| DUANE ARNOLD ENERGY CENTER | | CONNECTION DIAGRAM-SH.7 REMOTE SHUTDOWN PANEL PANEL IC388 | |
| PROJECT NO. 009560 | DATE 3-7-84 | DRWING NO. E8-5229-21 | REV. B |

DCP PACKAGE INDEX
 ITEM NO. 6.3.11

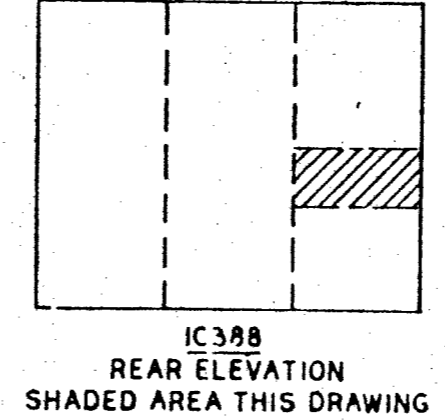
DRAFTING NOTE:
 CLOUDED WIRES & CABLES OR \odot CLOUDED WIRES & CABLES ARE NEW ADDED WIRES & CABLES. DO NOT DRAFT THE "O" ON THE WIRES & CABLES AT DCP CLOSURE.
